PLANNED UNIT DEVELOPMENT**Date: April 5, 2018****DEVELOPMENT NAME**

LOCATION2955 and 2989 Dauphin Street
(Southeast corner of Dauphin Street and Sage Avenue)**CITY COUNCIL****DISTRICT**

The applicant is requesting Planned Unit Development Approval to amend a previously approved Planned Unit Development to allow shared access between three lots.

SITE PLAN

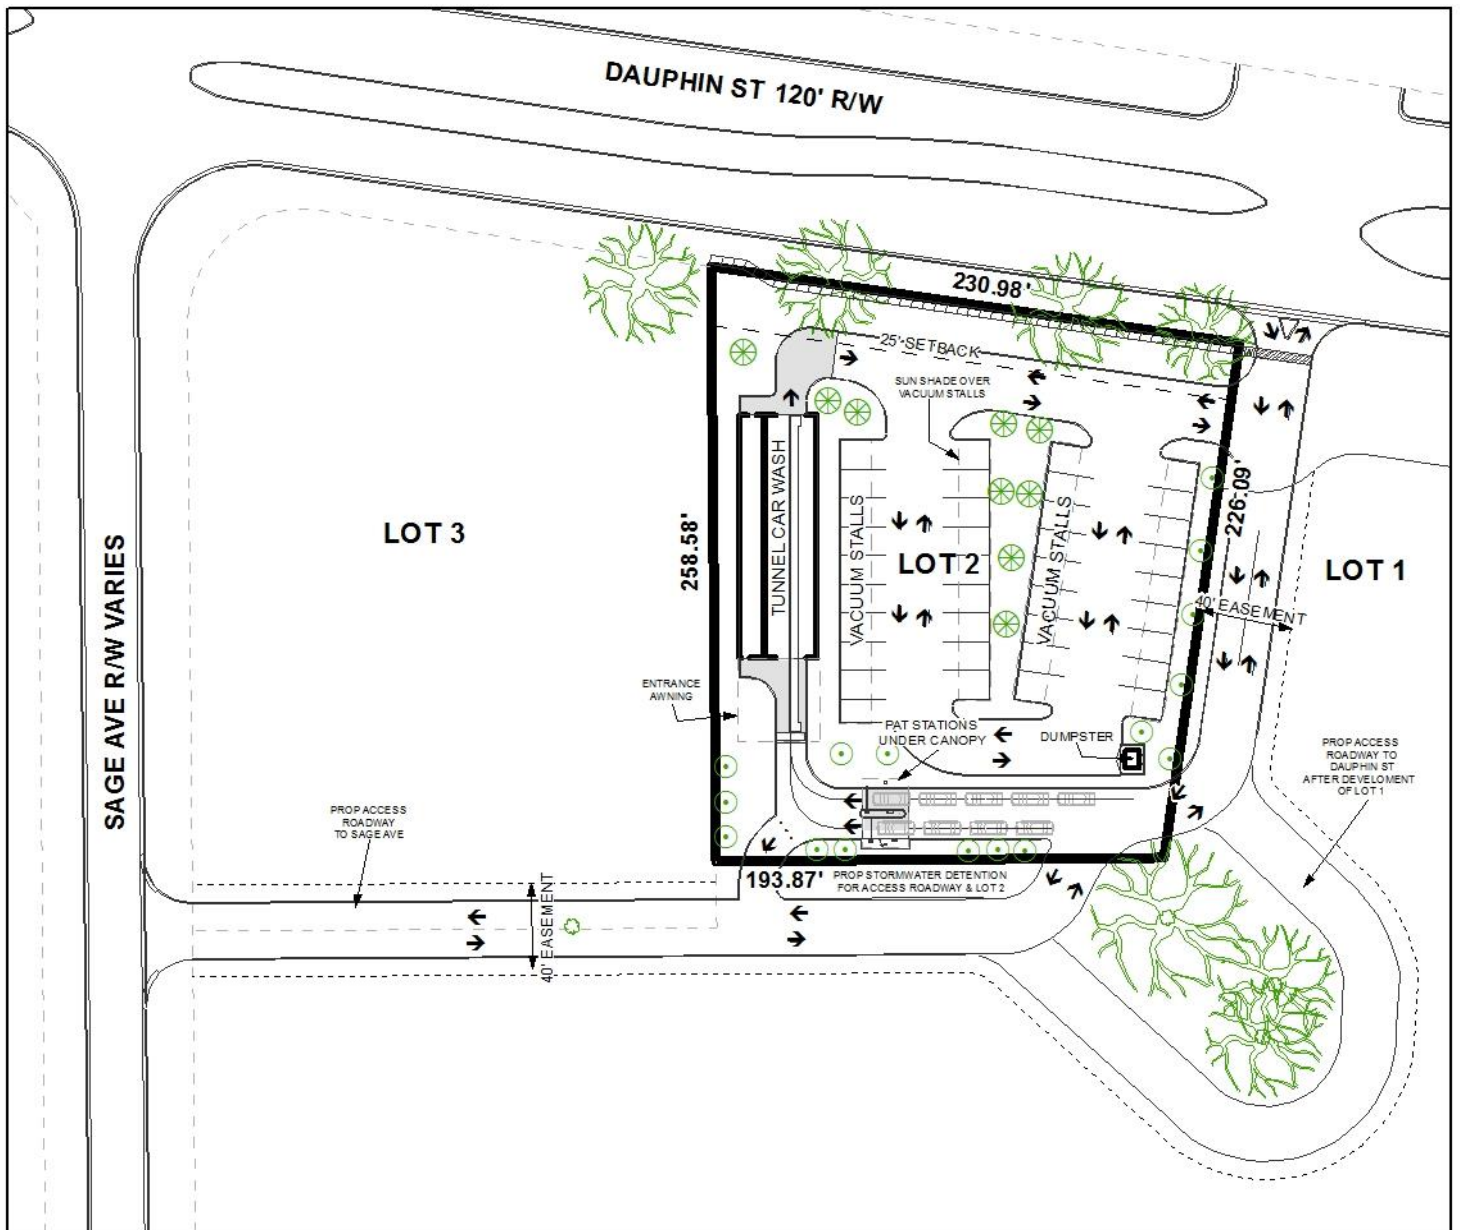
The lot fronts Dauphin Street, a major street according to the Major Street Plan component of the Comprehensive Plan, with a 120' right-of-way, which exceeds the 100 feet requirements, therefore no dedication will be required. The lot also has access to Sage Avenue via an access easement across two other lots that will be constructed and used to connect to Dauphin Street. The site plan depicts the right-of-way width along Sage Avenue as varying, however, information on the Final Plat, recorded in 2008, shows the right-of-way as 60' for Sage Avenue. The site plan should be revised to depict the accurate right-of-way width along this portion of Sage Avenue.

The 25' minimum building setback line is depicted on the site plan for the lot being developed and should be retained on any future plans.

All proposed parking areas for the site appear to be compliant in terms of travel aisle width, parking stall dimensions, and number of spaces; however, it should be pointed out that the site plan does not depict any accessible parking spaces/ vacuum stalls, therefore the site may not be in compliance with building code requirements and the Americans with Disabilities Act. The site plan should be revised to depict compliant accessible parking, which may include the provision of one accessible parking space and one accessible vacuum stall.

A sidewalk is shown along the frontage of the site as well as proposed dumpster location. The illustrations should be retained on any revised PUD site plan, along with a note acknowledging compliance with Section 64-4.D.9. of the Zoning Ordinance regarding dumpster compliance.

The site plan provides landscaping information and illustrates tree plantings, however the required amount of frontage trees for the site appear to be short. After allocations for the canopy overhang have been taken in account for the existing live oaks within the right-of-way, the site is still short 1 frontage tree. Adequate tree planting and landscaping for the remainder of the site is provided. A revised site plan depicting one additional frontage tree will be required. All revisions must comply with Section 64-4.E. of the Zoning Ordinance regarding tree and landscaping requirements.

In regards to the proposed car wash, full carwash compliance of the Zoning Ordinance is required. As such, all water run-off must be directed to the sanitary sewer system, an oil separator must be provided, and vehicles must be screened from view with at 3'-5' evergreen hedge and/or landscaped berm.

Lighting is not illustrated on the site plan. Any new lighting on the site will have to comply with the requirements of Sections 64-4.A.2., 64-6.A.3.c., and 64-6.A.8. of the Zoning Ordinance. A note reflecting this requirement should appear on the site plan, and photometric plans will be required at the time of submittal for land disturbance.

It should be pointed out that there was no signage information provided for the proposed site. If approved, the proposed development on Lot 2 will be limited to one freestanding sign and two wall signs.
